# DEVELOPMENT REVIEW BOARD REPORT

MEETING DATE: June 23, 2005

CASE NUMBER/ PROJECT NAME	<b>24-DR-2005</b> <b>Miller Holdings Airpark</b>		
LOCATION	14800 N. 78 <sup>th</sup> Way, at the northwest side of the intersection of 78 <sup>th</sup> Way and Raintree Road		
REQUEST	Request approval of a site plan and elevations for a new two-story office building and three hangars.		
OWNER	Miller Holdings Inc. 480-945-9292	ENGINEER	Hunter Engineering 480-991-3985
ARCHITECT/ DESIGNER	Larson Associates 602-955-9929	APPLICANT/ COORDINATOR	Jim Larson Larson Associates Architects Inc. 602-955-9929
BACKGROUND	<p><b>Zoning.</b></p> <p>The site is zoned Industrial Park (I-1) District. This district allows for airport and aviation related uses including hangers and aircraft staging areas, as well as office and warehouse uses as permitted uses.</p> <p><b>Context.</b></p> <p>The site is located within the Scottsdale Industrial Airpark Unit #6 plat</p> <p>Adjacent Uses:</p> <ul style="list-style-type: none"><li>• North: Scottsdale Airport and the associated taxiway and runway.</li><li>• South: 78<sup>th</sup> Way and I-1 office and warehouse uses.</li><li>• East: 78<sup>th</sup> Way cul-de-sac and oth

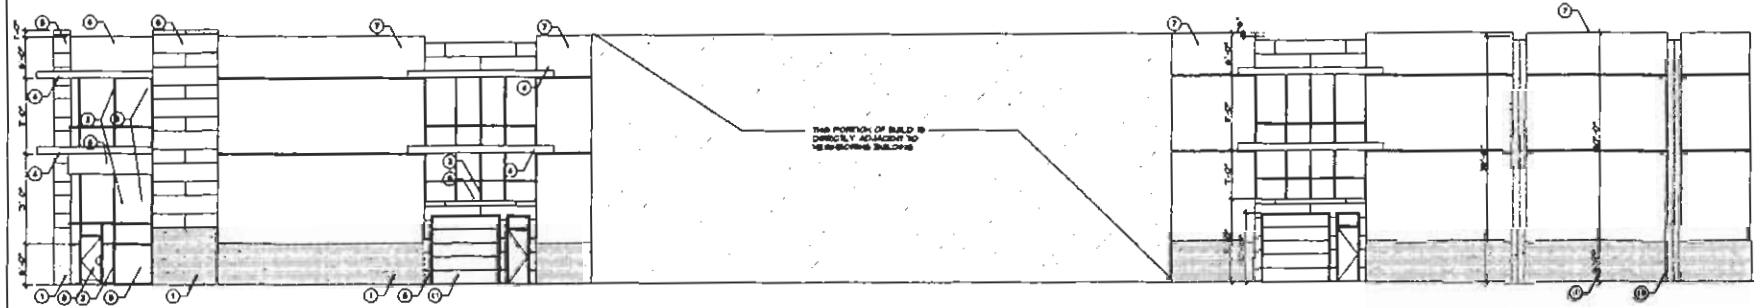
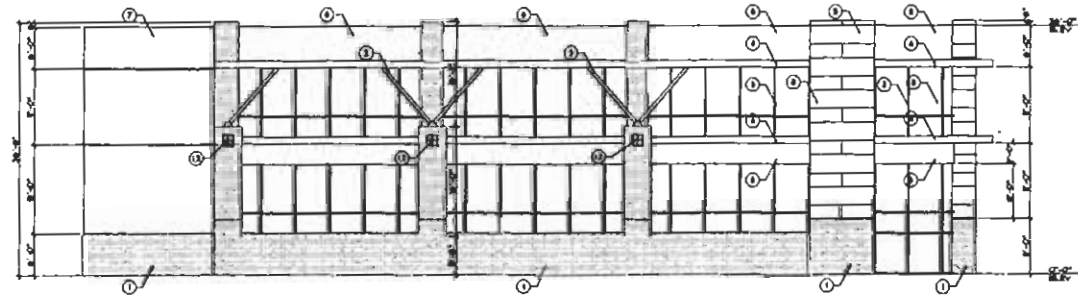
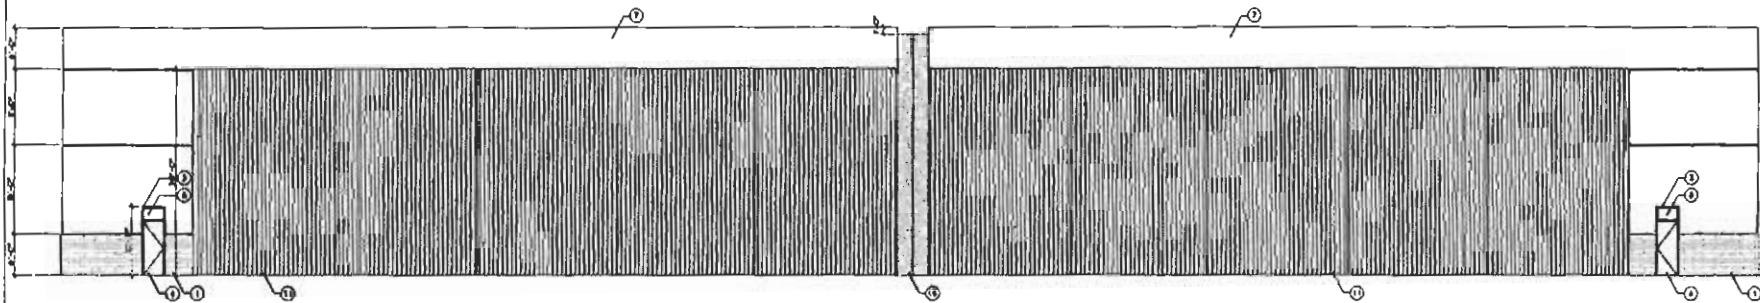
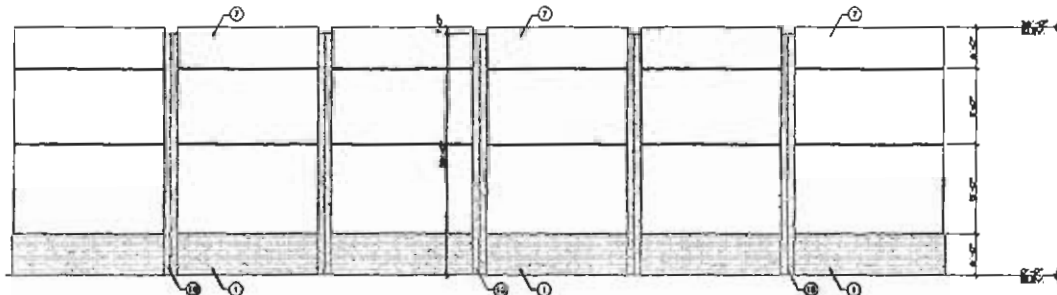
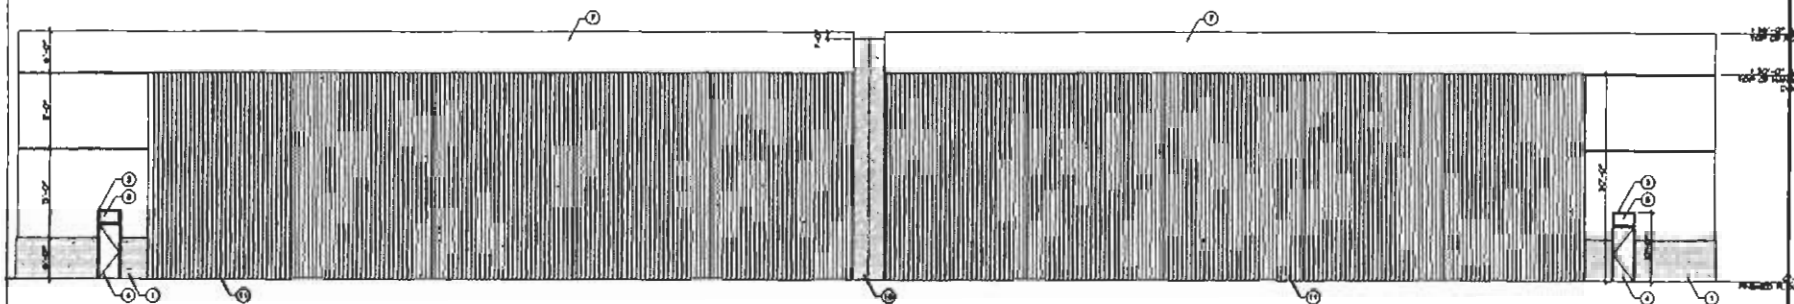
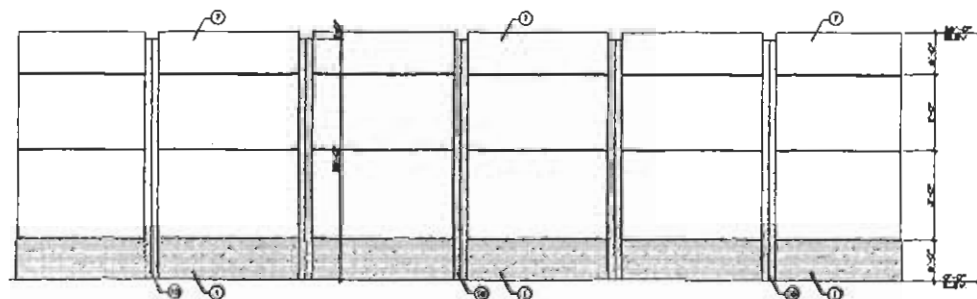
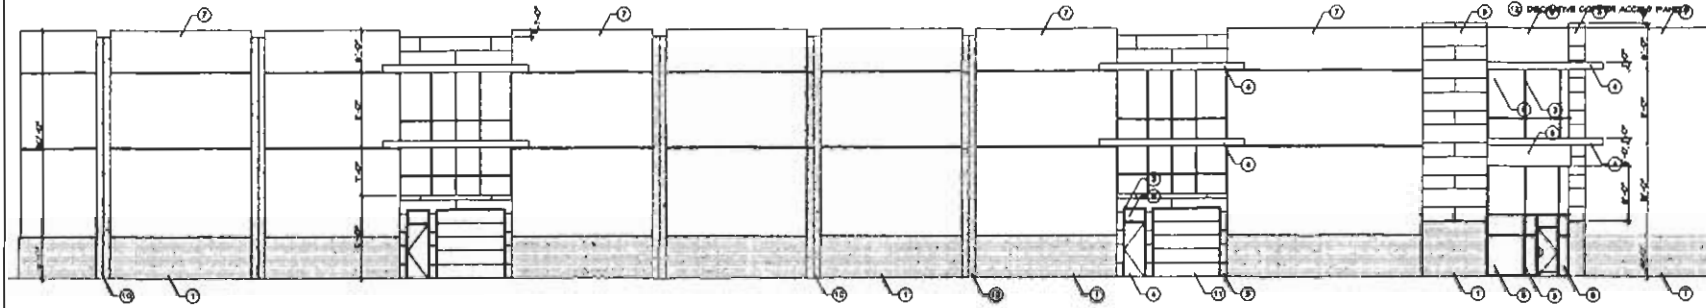
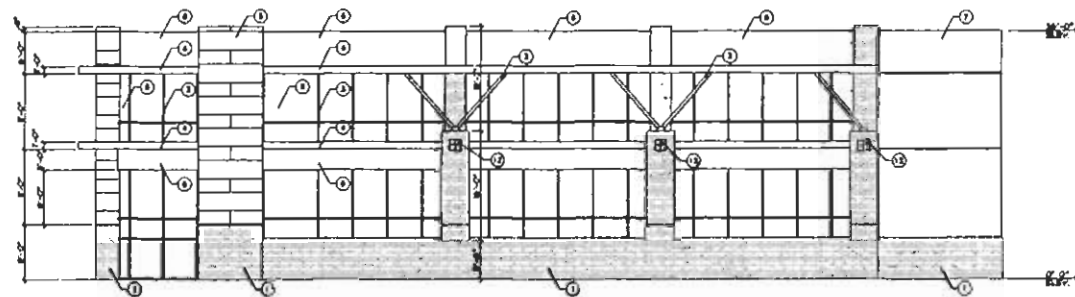
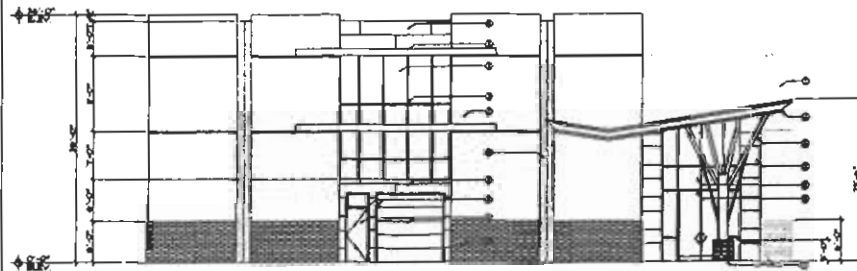
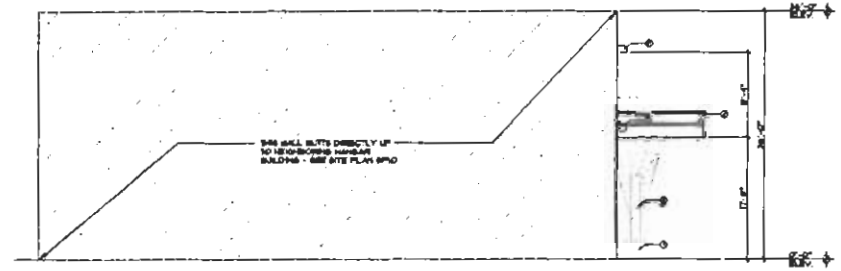
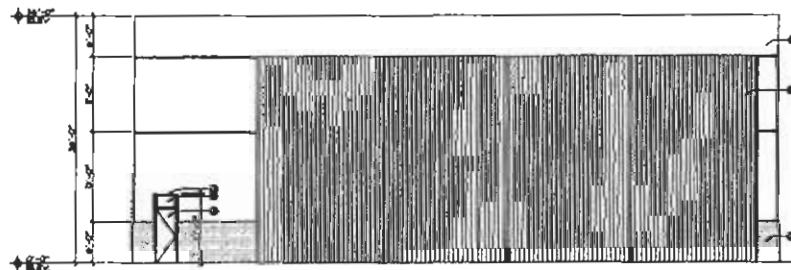
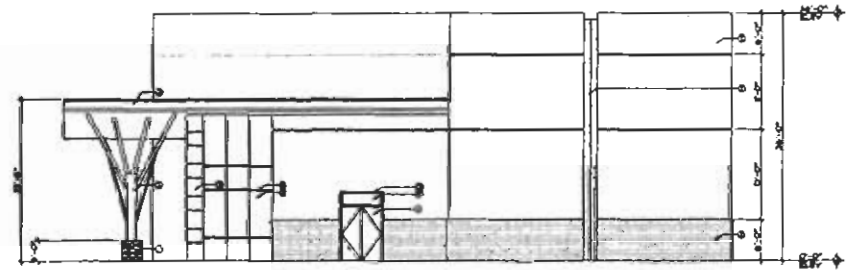
- A. *At time of the final plans submittal, the applicant shall revise the Building Elevations for all buildings to include a data table that shows the calculations used to determine building height compliance. Hangar*

*elevations shall note: Building height determined from top of pavement elevations taken from the adjacent taxilane.*
